**City of Pembroke Pines
 Planning & Economic Development Department
 601 City Center Way 3rd Floor
 Pembroke Pines FL, 33025**

Agenda Date:	February 13, 2025	Application ID:	SP2024-0010
Project:	Memorial Urgent Care	Project Number:	PRJ2024-0014
Project Planner	Cole Williams, Senior Planner		
Owner:	South Broward Hospital District	Agent:	Hope Calhoun
Location:	10175 Pines Boulevard	Commission District	2
Existing Zoning:	B-3 (General Business)	Existing Land Use:	Commercial
Reference Applications:	ZV 2012-02, ZV 2012-01, SP 2011-22		
Applicant Request:	Architectural and site modifications		
Staff Recommendation:	Approval		
Final:	<input checked="" type="checkbox"/> Planning & Zoning Board	<input type="checkbox"/> City Commission	
Reviewed for the Agenda:	Director: <u></u>	Assistant Director: <u></u>

Date: February 3, 2025
To: SP 2024-0010 file
From: Cole Williams, Senior Planner
Re: Memorial Urgent Care

DRAWN TW
CHECKED TW
DATE 11-20-2023
SCALE 1"=20'
Sheet No. **L-2**
Sheet 2 Of 2

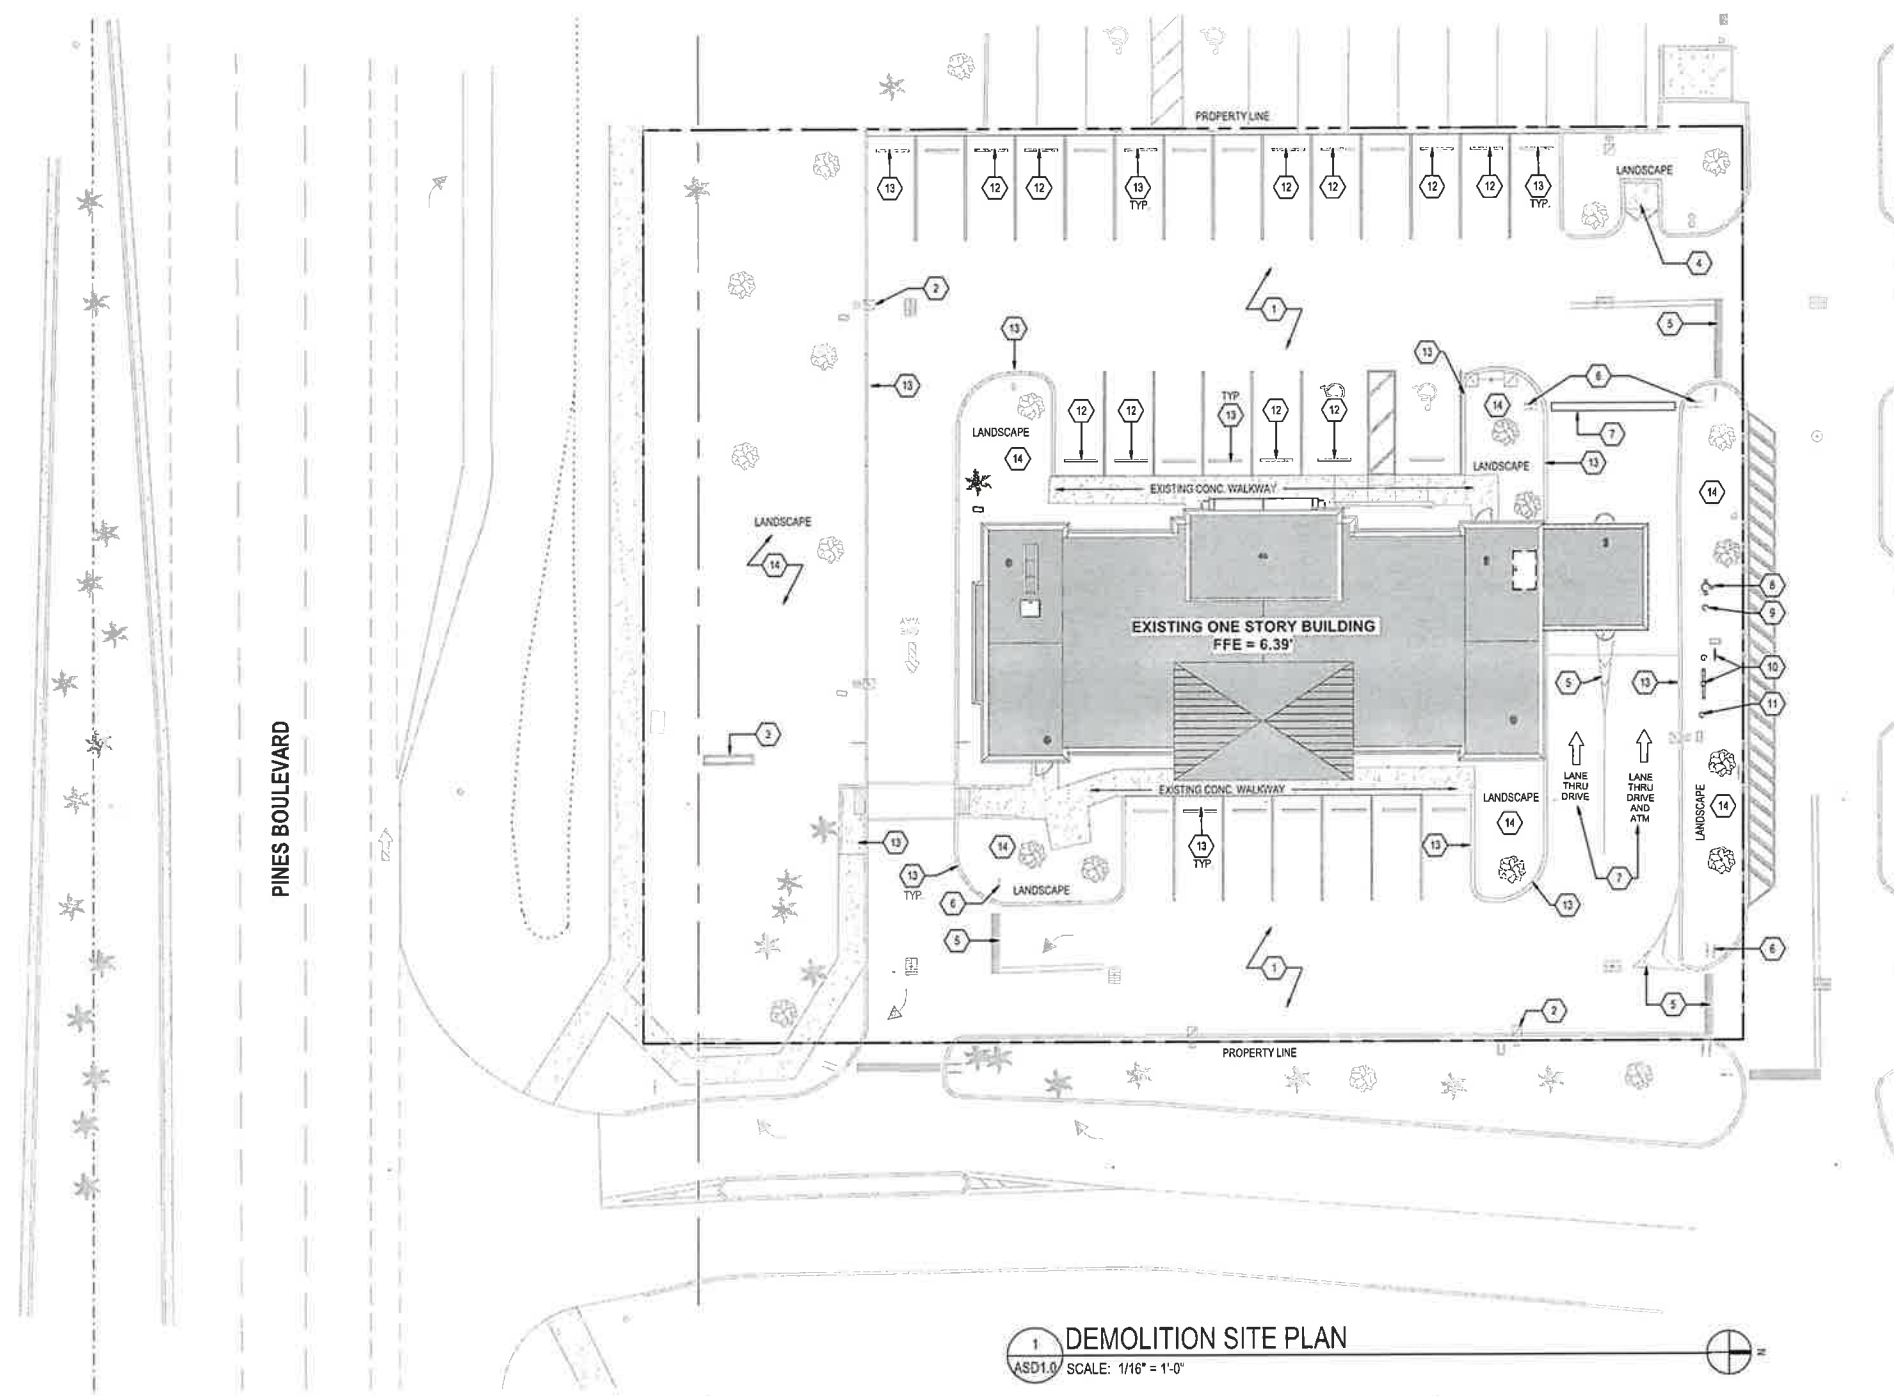
- 4. Please add a memo to the plans to reference the new Code amendment requirements pertaining to the maintenance of plant materials within interior parking islands. As per LDC SEC. 155.663 (E) - Individual interior parking lot areas shall be a minimum of 100 square feet total adequately landscaped with shrubs, groundcover, or other authorized landscape material not to exceed 24 inches in height in addition to requirements listed below. Unable to locate the memo on L-2.**

20. On sheet L-2, the Southern buffer, there is one (1) symbol (next to queen palm and existing cocoplum) but no callout. Symbol appears to be the same as a multi-trunk palm, however, no multi-trunk palm noted in said location. Please clarify.

21. On sheet L-2, the Southern buffer has a callout which is identified as "miscellaneous berm shrubs", staff is unable to accept this, as the plans must show all existing materials on site, by species. Please have all shrubs remaining or to be installed in the said area, identified and shown on the plans.

1 PROPOSED SITE PLAN
AS1.0 SCALE: 1/16" = 1'-0"

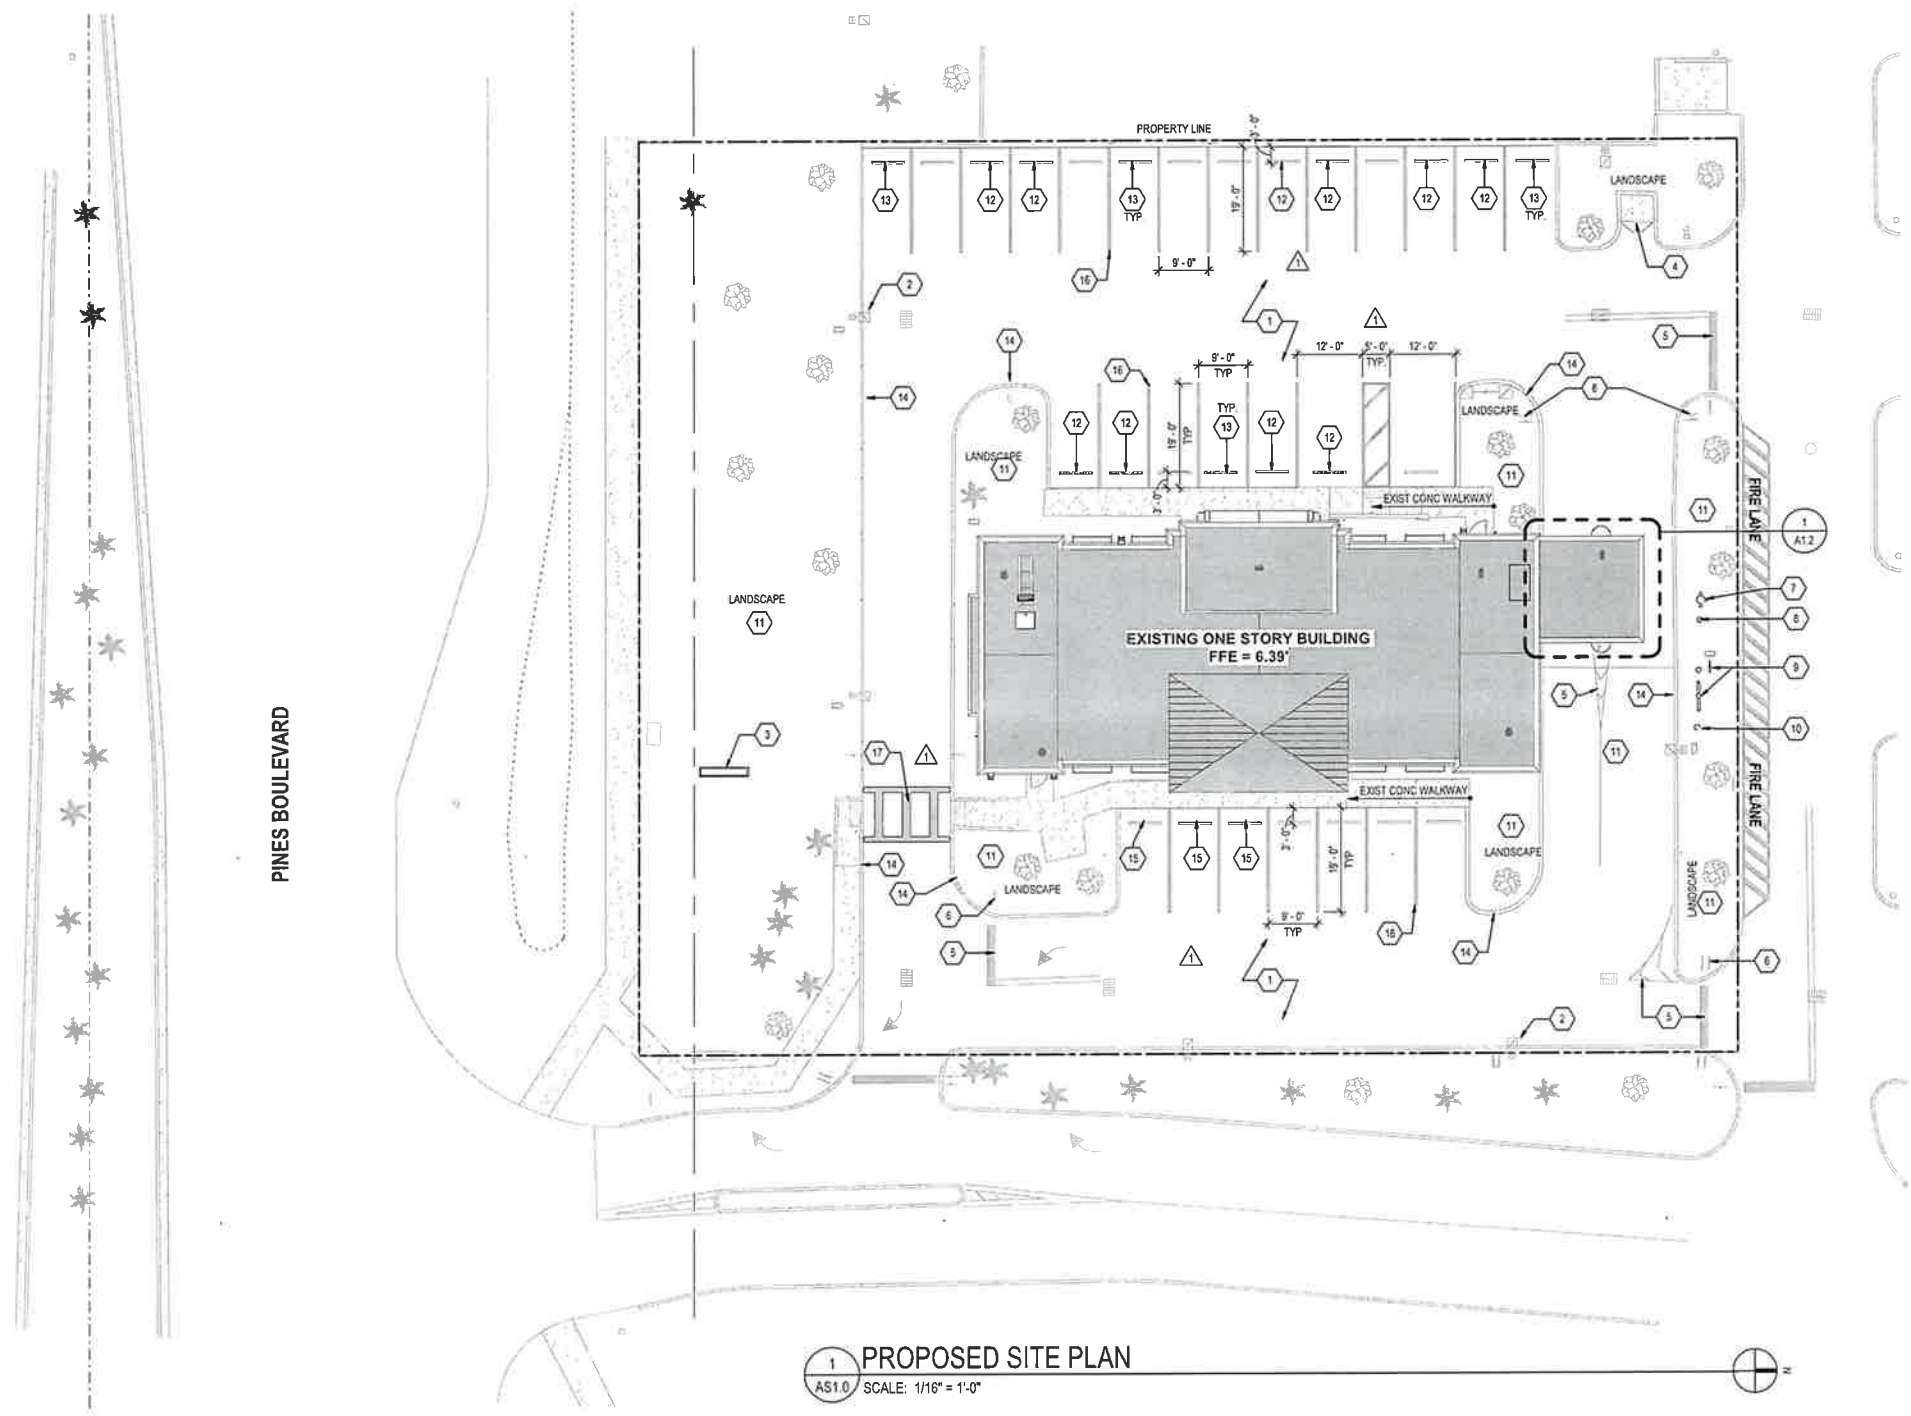
1. Provide 10' Wide 'Special Emphasis Crosswalk' markings (Thermoplastic) for the proposed Accessible Crossing of the access drive at the southwest corner of the existing building per FDOT Standard Plans Index 711-001.

2. Provide 25 LF of 6" Double Yellow Centerline markings with Yellow/Yellow RPM's at 20' O.C. for the 'Stop' condition at the northeast access drive and southwest parking access drive.

9. All existing parking spaces are to be striped with 4" reflective paint markings per City Standard R-32 and R-41. All parking spaces are to have two (2) stripes, including those parking spaces abutting a terminal landscape island on the side of the parking space. Parking spaces are not permitted to be striped with two (2) parallel stripes as current depicted on the Site Plan.
